80-88 Regent Street, Redfern

Response to Submissions

November 2016

Figure 1: Proposed as submitted of the left and current amended proposal on the right.

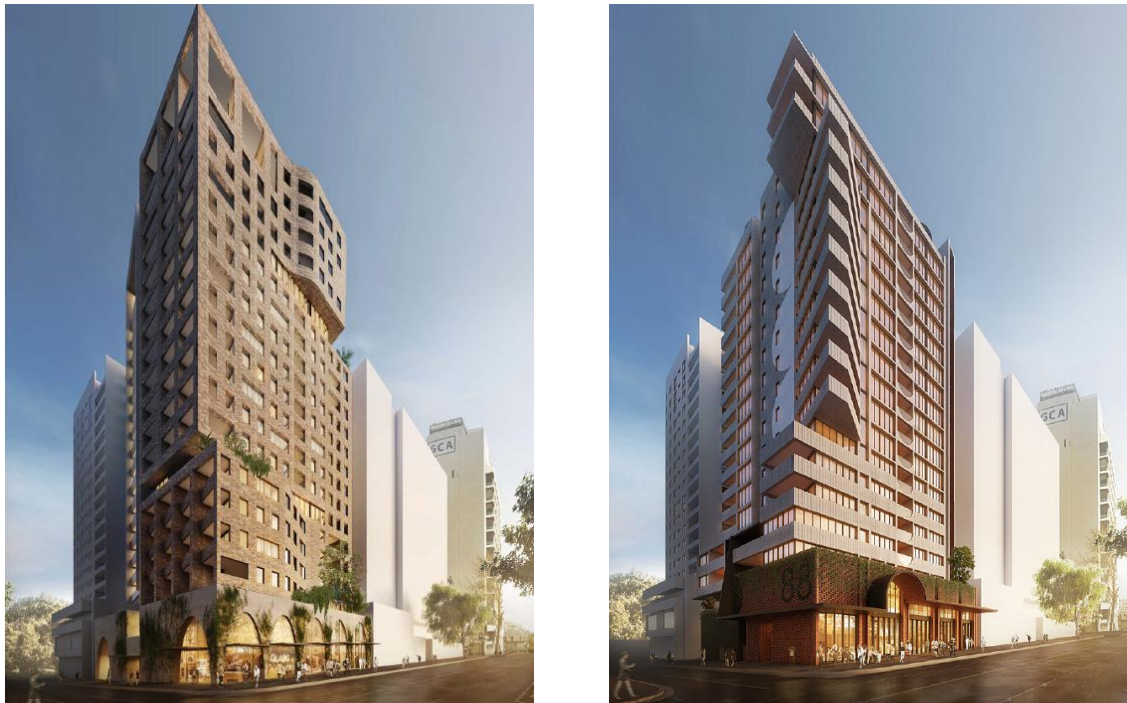
The height and massing of the podium to Marian Street has modified to better respond to the podium of 7-9 Gibbons Street; by harmonising with the effected datum lines, overall massing and setbacks a plane for unobstructed sight lines down the length of Marian street has been realized.

Hit and miss brickwork has been incorporated into both Regent and Marian Street facades for greater articulation and permeability at the pedestrian junction.

Consideration has been given to the ground floor configuration to improve the retail frontage and opportunities for interactions with the public domain though extending the tenancy to wrap around the corner of Marian Street through an active external courtyard.

Figure 2: 1.5m setback to Marian Street at ground and Level 1

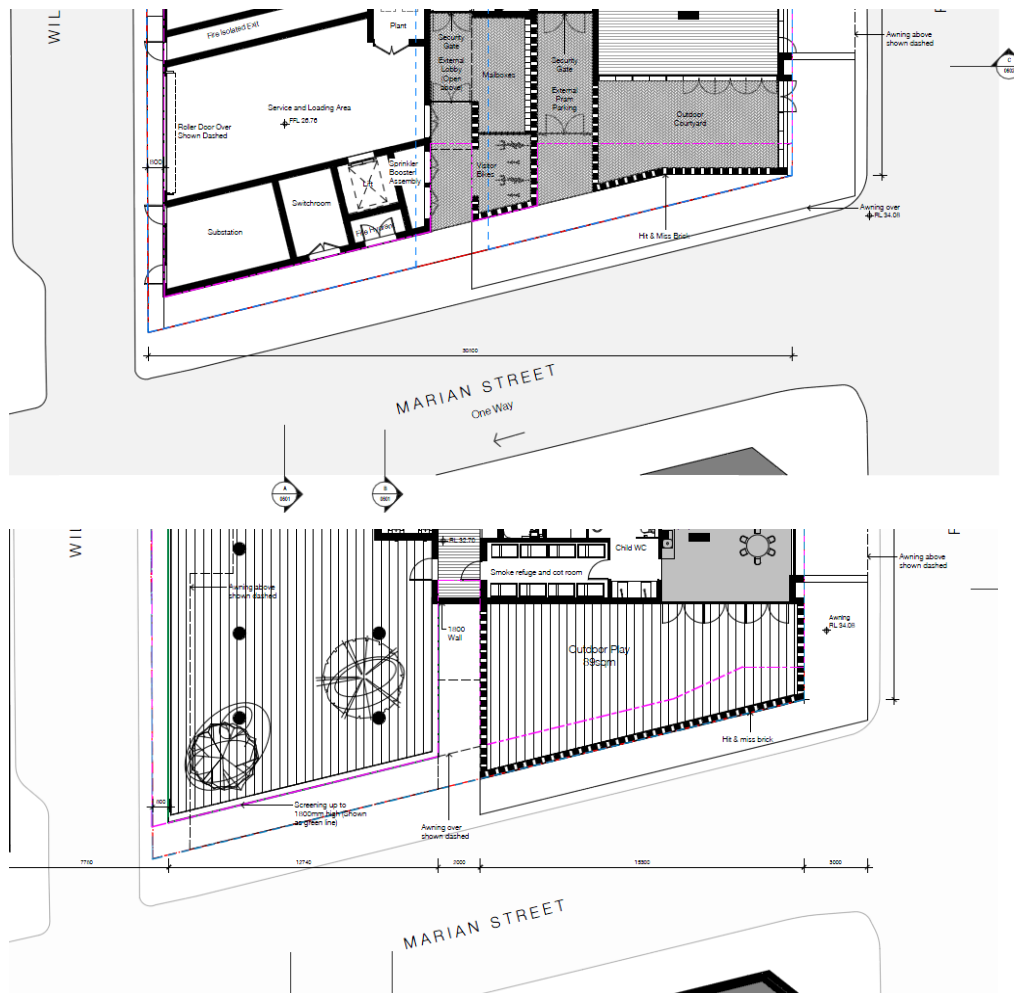
The ground level has been setback 1.5m from the Marian Street boundary consistent with the Draft Urban Design Guidelines (Redfern Centre). This is in line with the setback of 7-9 Gibbons Street and will provide for a wider footpath on Marian Street as was envisaged under the Guidelines.

The 1.5m setback tapers towards the corner with Regent Street as shown in Figure 2 below. The 1.5m additional setback also been carried through to level 1 on the western wing of the building (refer to Figure 2 below).

Figure 3: Amendment to setback to tower on Marian Street

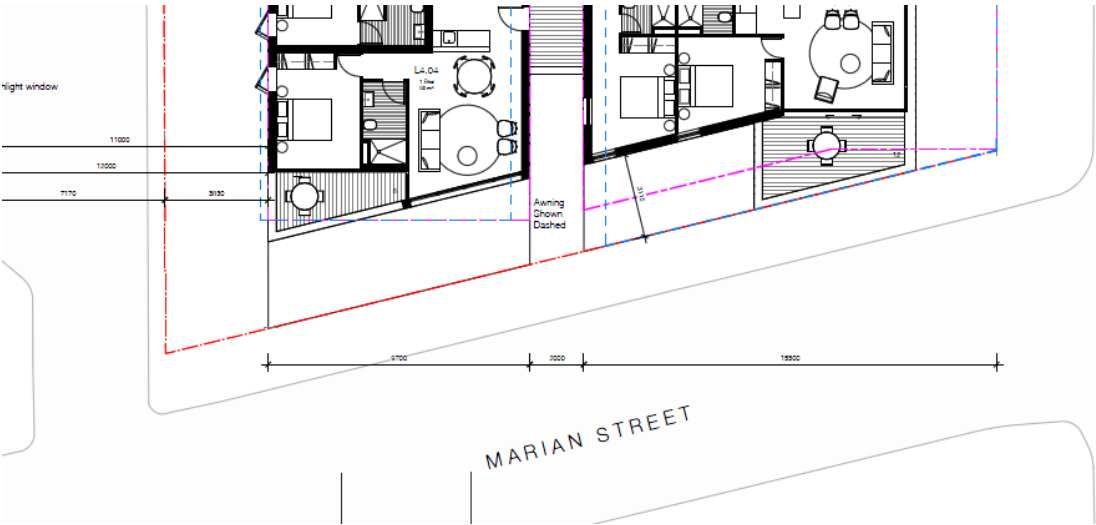
As illustrated in Figure 3 the amended proposal provides a predominant 3.15m setback to Marian Street. While this does not comply with the 4.0m Marian Street tower setback, the extent to which the tower encroaches into this setback has been reduced in comparison to the original DA and the initial RTS schemes. This is highlighted on the architectural drawings, with the blue line representing the tower footprint in the original DA submission and purple line representing the footprint of the tower in the RTS submitted August 2016).

As shown in Figure 3 and detailed in Table 4, the tower setback as been increased to a predominant 3.15m from Level 4 to 17. This excludes a minor splay and balcony towards the corner of Marian and Regent Street. As a result, the reduced non-compliance with the 4m tower setback has been reduced to a predominant variation of 0.85m, or 85cm. The increased and more consistent tower setback to Marian Street provides a four (4) storey podium form, more in keeping with the scale of the existing podium at 7-9 Gibbons Street.

Figure 4: Tower setbacks to Regent Street – Level 2

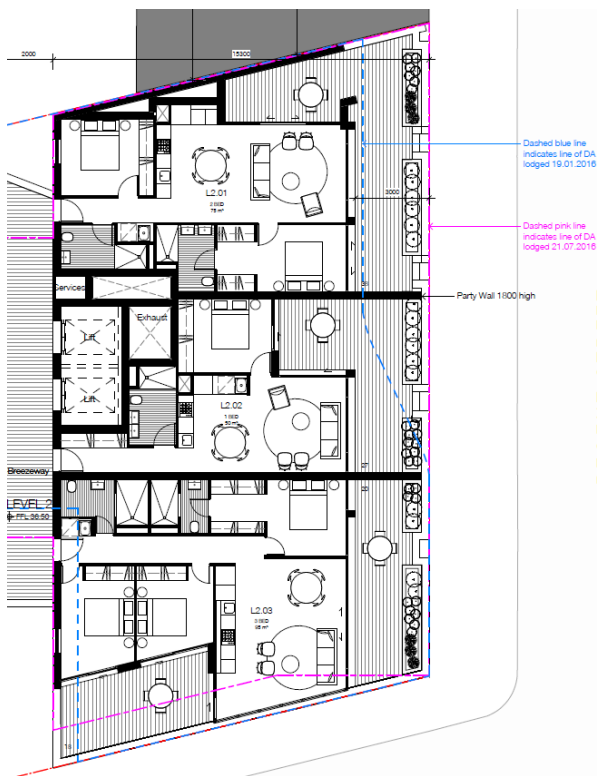
The original DA did not comply with the 8.0m setback with a variable setback to Regent Street ranging from 0m to 2.85m. The 2.85m setback was in keeping with the 3.0m tower setback that was provided for the approved Iglu development at 60-78 Regent Street. In the subsequent amended scheme the location of the available setback was reversed.

As illustrated in Figures 4 to 8, the current amended proposal provides a consistent 3m setback to Regent Street, with the exception of a balcony encroachment on levels 7-15, near the corner of Marian Street. This aligns with the 3.0m setback of the Iglu development.

Figure 9: Amended tower setback and 4 storey podium to Marian Street

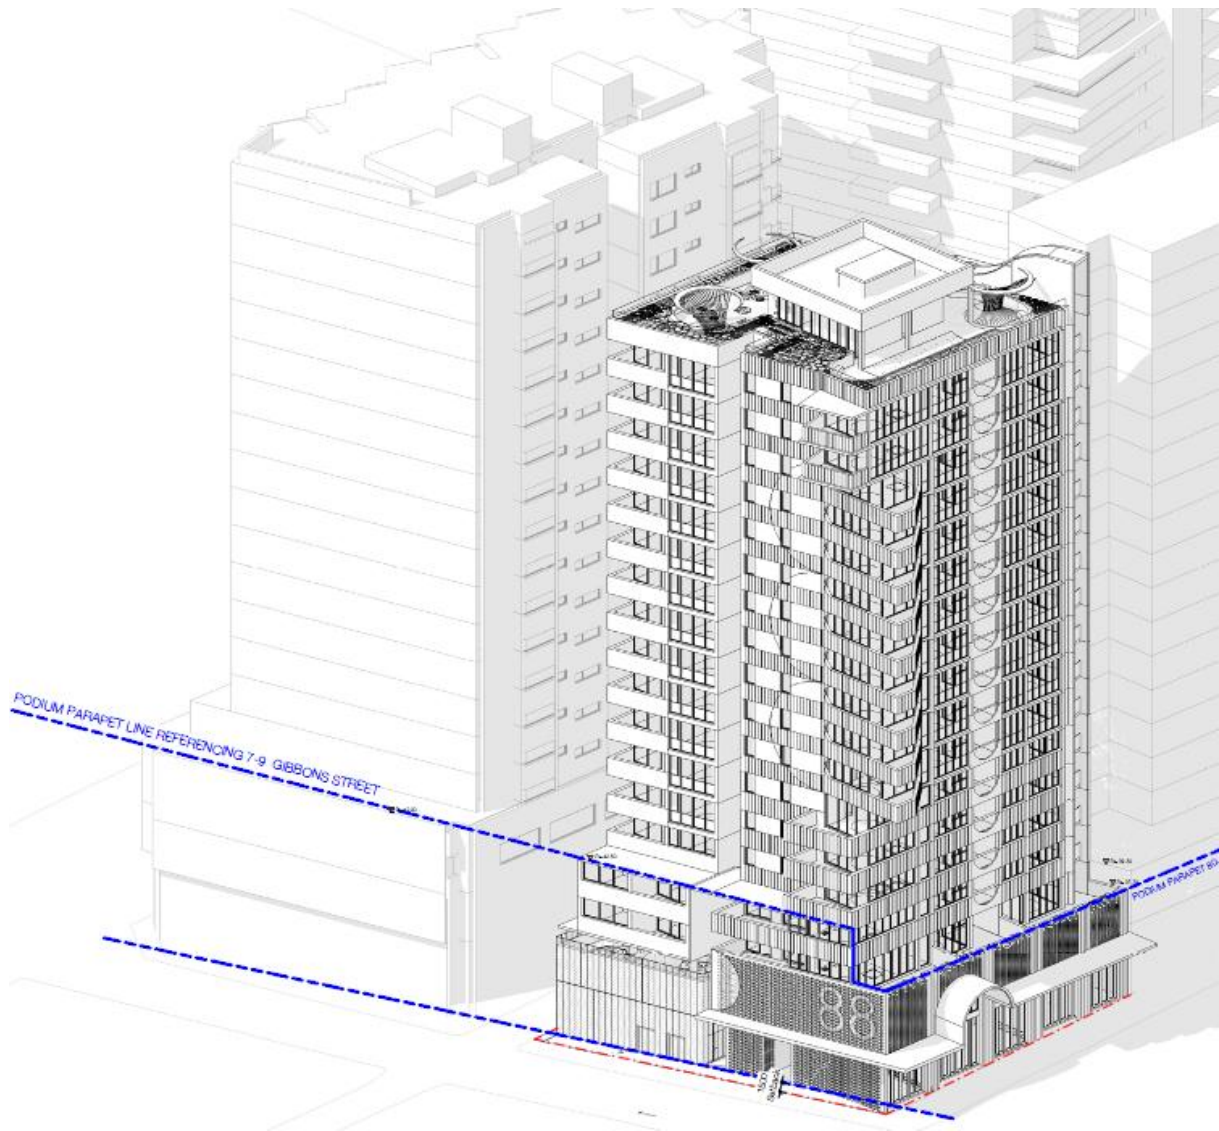
- The increased 3.15m tower setback and four (4) storey height and massing of the podium Marian Street responds to the podium of 7-9 Gibbons Street as illustrated in Figure 9.

Figure 10: Original (exhibited) tower and podium setbacks and the amended proposed setbacks on the right

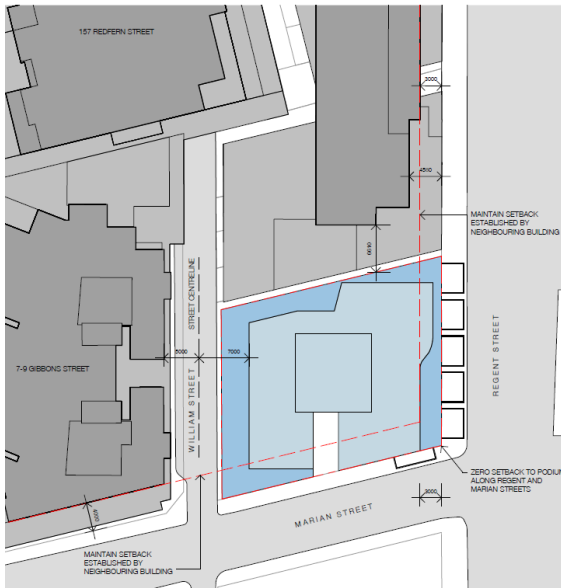
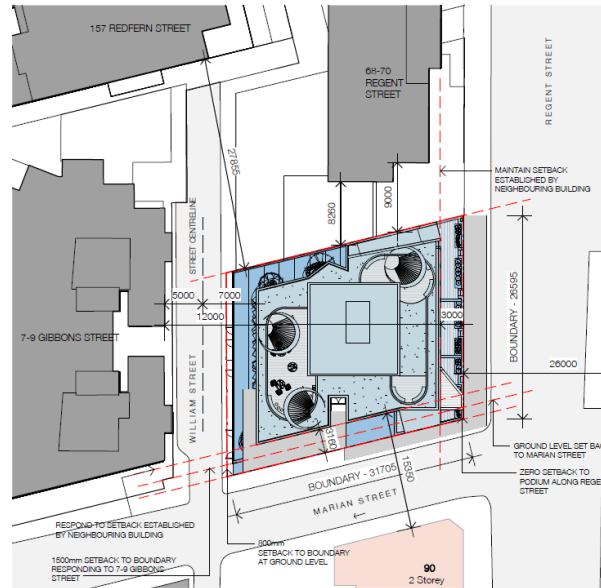
Setbacks to the northern boundary with the Iglu development vary from 0m to 3m, which results in a variable separation of 6.7m to 9.175m. To avoid privacy impacts on Iglu, there are no openings within the part of the northern elevation that has a 0m setback, which is consistent with the ADG design guidance provisions for privacy. Balconies are orientated to the east (Regent Street) and not towards the Iglu development.

There was very little scope to increase separation distances to 7-9 Gibbons Street to the west and provide a viable floor plate. As such the separation distances to the west remain unchanged. However screened (hooded) windows have been provided along this elevation to minimise privacy impacts on 7-9 Gibbons Street.

Table 6 provides a comparison of the separation distances and setbacks between the original DA and the proposed amended DA. This is illustrated in the extracts of the Design Options Analysis (Attachment 6) included at Figures 10 and 11-15.

Figure 21: Views to the south from the balconies and living rooms of 'Apartments D' at 7-9 Gibbons Street will not be impacted by the proposal (image from level 8)

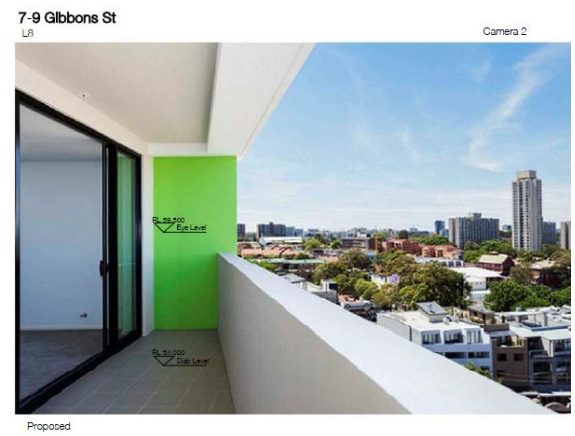
Views to the south from the living room and balcony of the 14 type 'D' apartments on Levels 4 to 17 will not be impacted by the proposal (refer to Figure 20). These apartments have a narrow, secondary balcony off the living room which has views to the east. The proposal will obscure views from this balcony and the balcony windows (refer to Figure 21). The views from the bedroom will also be obstructed. It is noted that these bedrooms have highlight windows, which limits the extent of the view. Overall the impacts on the 14 type 'D' apartments on Levels 4 to 17 of 7-9 Gibbons Street represents a minor to moderate impact given the nature of views to the east that will be obscured and that the views to the south will not be obstructed.
